Access Compliance Report

Public Rights-of-Way

(Curb Ramps)

Intersection ID: 30301	Main Street: BLACK_KETTLE_DR	Cross Street: SHINKANSEN_DR	Location: S
ADA ID: 1F1D0B4F68C4	Ramp Type: PerpDiag	Initial Pass/Fail: Fail	Overall Compliance: No
Severity Score: 8.75			
Codes/Mitigation Info/Possible Solution		Field Measurements/Component Compliance

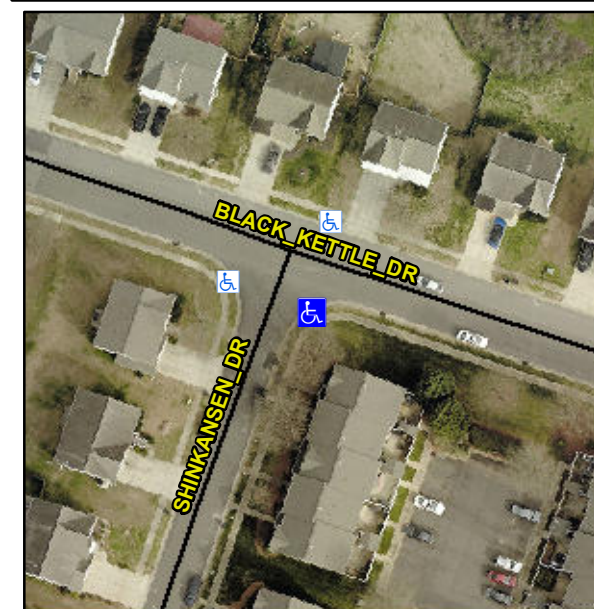
Not Found, R304.5.1

Compliance	Description	Data	Compliance	Description	Data
N/A	Ramp Length (in)	48.0	Yes	Ramp Slope (%)	7.7
No	Ramp Width (in)	40.5	Yes	Ramp XSlope (%)	0.8
N/A	Flare Type LT	N/A	N/A	Flare Type RT	N/A
N/A	Flare Slope LT (%)	N/A	N/A	Flare Slope RT (%)	N/A
N/A	Flare Traversable LT?	N/A	N/A	Flare Traversable RT?	N/A
N/A	Landing Length (in)	N/A	N/A	DWS Provided?	N/A
N/A	Landing Width (in)	N/A	N/A	DWS Contrast?	N/A
N/A	Landing Slope (%)	N/A	N/A	DWS Length (in)	N/A
N/A	Landing X Slope (%)	N/A	N/A	DWS Full Width?	N/A
N/A	Landing Curb? (Y/N)	N/A	N/A	DWS Offset (in)	N/A
N/A	Shared Landing?	N/A			
N/A	Gutter Ponding?	N/A	N/A	Gutter Slope (%)	N/A
N/A	Gutter Lip Ht (in)	N/A	N/A	Gutter X Slope (%)	N/A
N/A	Painted X Walk1?	No	N/A	Painted X Walk2?	No
	X Walk 1 Direction	To NE		X Walk 2 Direction	To NW
N/A	X Walk 1 Width (in)	N/A	N/A	X Walk 2 Width (in)	N/A
	X Walk 1 Slope (%)	2.3		X Walk 2 Slope (%)	1.8
	X Walk 1 X Slope (%)	3.0		X Walk 2 X Slope (%)	0.7

Remove & Replace Curb Ramp With Two New Directional Ramps or Equivalent.
